Review: PIE AQM draft-ietf-aqm-pie-00

Bob Briscoe, BT*

IETF-93, Praha, July 2015

Summary of full 20pp review

'Autotuning' α & β parameters

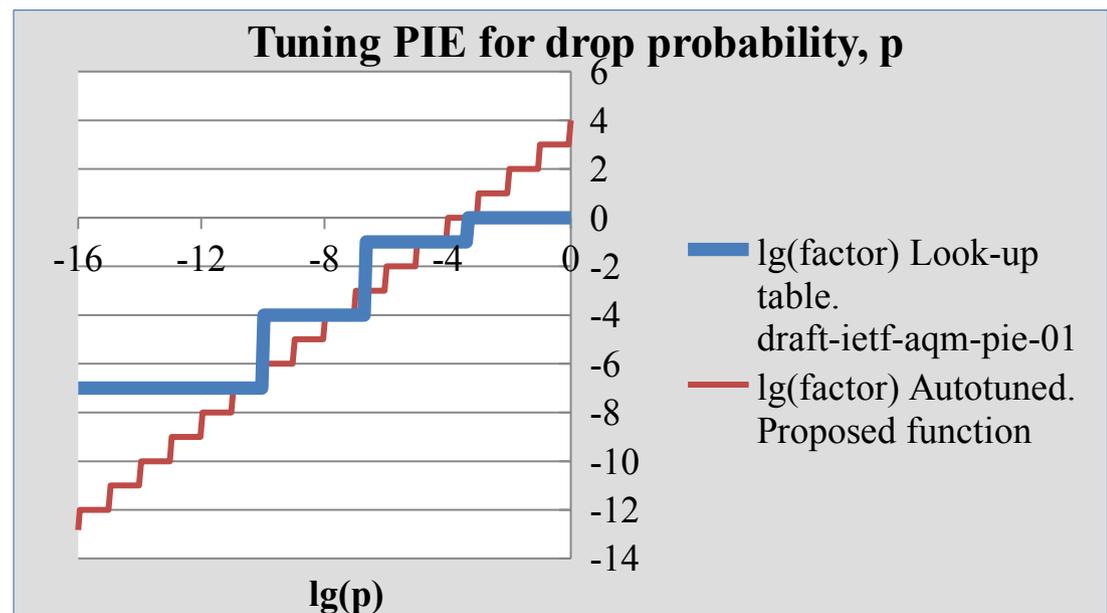
if (p < 0.1%) {
    p += [alpha*(qdelay - QDELAY_REF) + beta*(qdelay-PIE->qdelay_old_)]/128;
} else if (p < 1%) {
    p += [alpha*(qdelay - QDELAY_REF) + beta*(qdelay-PIE->qdelay_old_)]/16;
} else if (p < 10%) {
    p += [alpha*(qdelay - QDELAY_REF) + beta*(qdelay-PIE->qdelay_old_)]/2;
} else {
    p += alpha*(qdelay - QDELAY_REF) + beta*(qdelay-PIE->qdelay_old_);
}

Instead of a look-up table for the factors,
propose to use $p*16$ as the factor
Using bit-shifting to avoid multiplication (see review)

4. Burst allowance too high or even unnecessary?

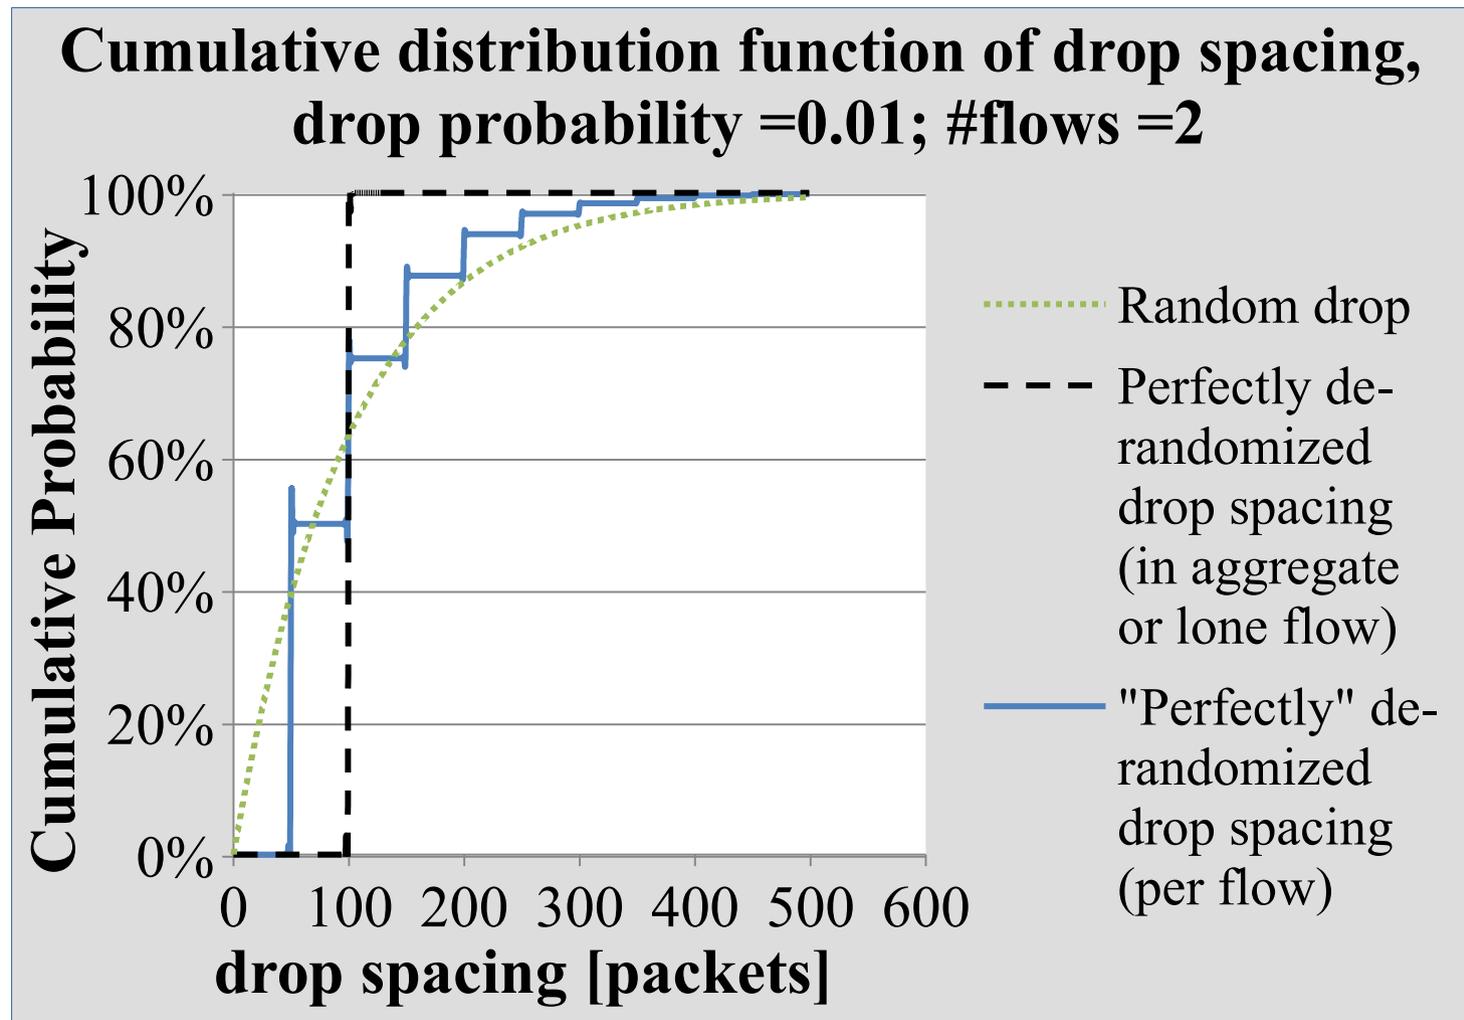
- 150ms is 5-15 round trips for most traffic (CDNs)
 - burst allowance is meant to filter out transients
 - If AQM takes >1 RTT to start dropping → delay & tail drop
- PIE already filters bursts (queue sampling and evolution of drop_prob)
 - Have you tried removing this additional burst allowance?
